Technical Information	TI No. TI-20240321-EH32	Page 1 of 4
Related markets All overseas markets	Date Released: 2024.3.21	
Applicable Model EH32 XPOWER	Please convey to your <input checked="" type="checkbox"/> AS Director <input checked="" type="checkbox"/> Technical Dept. <input checked="" type="checkbox"/> Warranty Dept. <input checked="" type="checkbox"/> Parts Dept. <input type="checkbox"/> PDI Center <input type="checkbox"/> Sales Dept.

Subject: EH32 XPower High-speed Vibration Solution

A AXIS

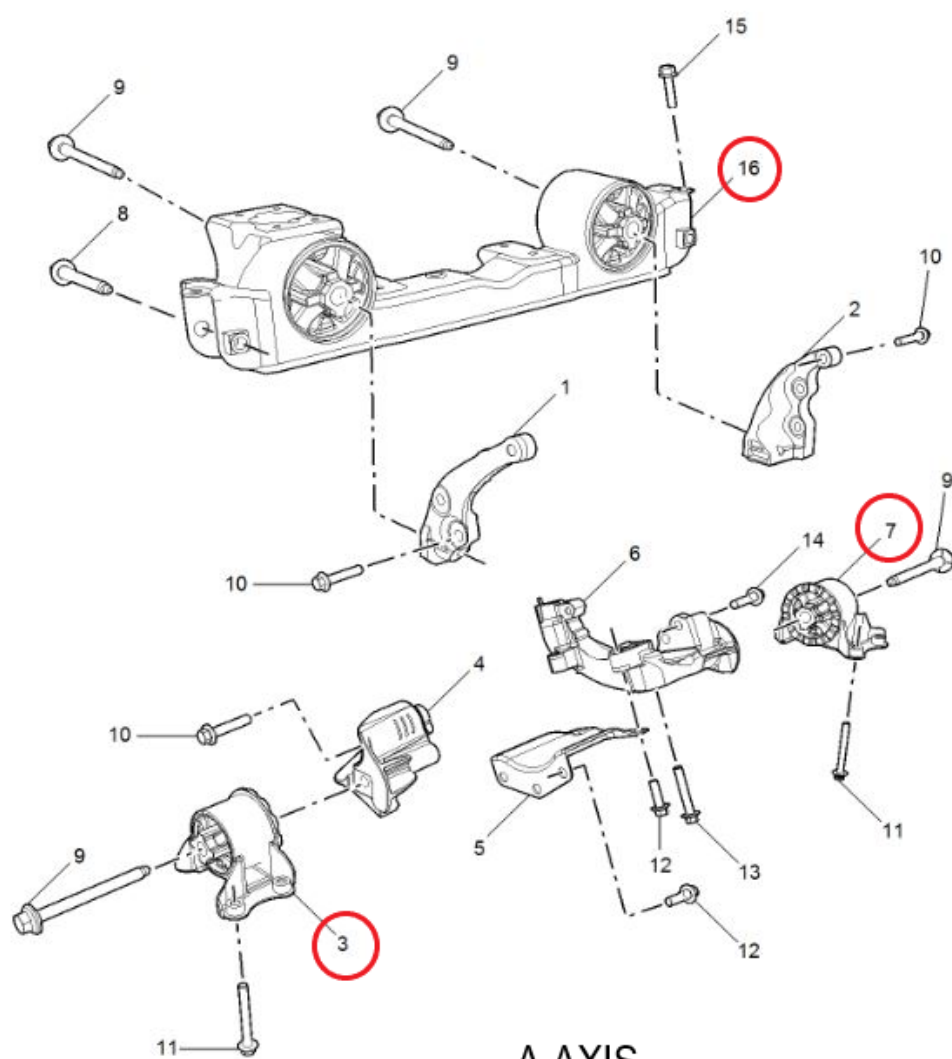
6. After-sales suspension solution:

Note: This repair work requires high technical works and is recommended to be performed only for individual customers who have severe complaints. It is not recommended for after-sales service campaign.

Part No.	Part Description	Qty	Remark
11634105	MOUNT ASM-LR	1	A AXIS-7
11634111	MOUNT ASM-RR	1	A AXIS-3
11768662	CROSSMEMBER-ENG MT FRT UPR	1	A AXIS-16
11611888	FRAME ASM-RR SUSP	1	B AXIS-1
